COUNCIL ASSESSMENT REPORT

HUNTER AND CENTRAL COAST REGIONAL PLANNING PANEL

PANEL REFERENCE & DA NUMBER	PPSHCC-160 – DA2022-01317
PROPOSAL	DA2022-01317 - Stage 2 involving demolition of existing structures and the erection of a mixed use development proposing 122 apartments, retail premises and associated parking, landscaping, services and associated two lot subdivision.
ADDRESS	Lot 1 DP 867617 - 711 Hunter Street Newcastle West
APPLICANT	Urbis Pty Ltd
OWNER	Hunter Street JV CO Pty Ltd
DA LODGEMENT DATE	17/11/2022
APPLICATION TYPE	Development Application
REGIONALLY SIGNIFICANT CRITERIA	Section 2.19(1) and Clause 2 of Schedule 6 of State Environmental Planning Policy (Planning Systems) 2021 declares the proposal regionally significant development as: Development that has a capital investment value of more than \$30 million.
CIV	\$54,968,646.00 (excluding GST)
CLAUSE 4.6 REQUESTS	<ul style="list-style-type: none"> • CI4.4 – Floor Space Ratio NLEP 2012 • CI7.4 – Building Separation NLEP 2012

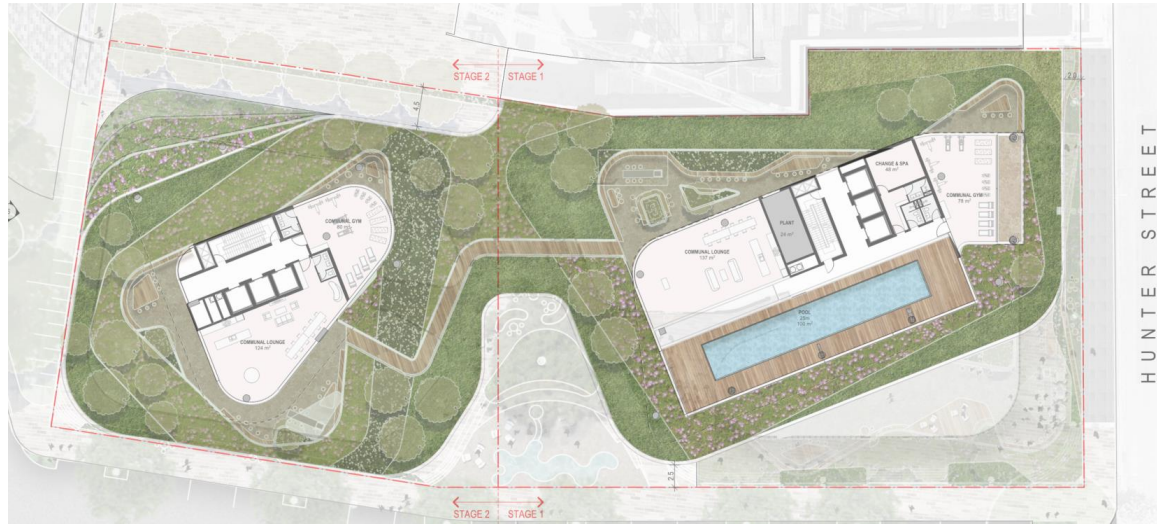
While the landscape proposal has to some extent addressed some noted concerns, it was noted by the Panel that podium level private open spaces remained extremely large, at the expense of more expansive and appropriate areas of living plants that contribute to both the external appearance of the development – which was a feature of the winning competition design – and to resident enjoyment of the communal spaces as *soft-landscaped areas*.

Furthermore, the limited perimeter planting, estimated by the proponent to be in the order of only 1.5m in width, was proposed to serve also as the access way for maintaining the planter beds. This arrangement is considered to be quite unworkable, and should be reconsidered with proper provision made for safe, convenient access for maintenance of all the contributory planter beds across the podium, and for considerably larger areas of soft landscape. This maintenance access needs to take account of the periodic need to access plants for pruning and mulching, and the less frequent need to replace soils and plants.

While there has been some increases in the planted areas outside bedroom windows that can act as a setback from communal spaces, this separation remains less than desirable for achieving reasonable levels of privacy. This should be reconsidered as part of the recommended overall increase in soft landscape area on the podium in lieu of synthetic turf and some hard paving.

The proposed amended design, as reviewed by the UDRP, has not been further revised by the applicants to resolve the issues associated within the proposed landscaping design, synthetic turf and the design layout in terms of the ratio of communal open space to private open space.

Communal vs Private Open Space – The amended landscape design, as reviewed by the UDRP, has been raised as a concern considering the extent to which the current design has changed from the winning competition entry, the extracts below provide a broad comparison of the differences. The extent of private open space on the podium compared to the communal landscape area is a concern. It is further noted that compliance, or exceedance, of the ADG requirements does not necessarily equate to a design excellence outcome.

A condition of consent on a deferred commencement basis is recommended at **Attachment A**, requiring that the ratio of communal open space to be increased when compared to private open space for the dwellings on this level podium. The additional communal open space area is to incorporate additional landscape plantings.
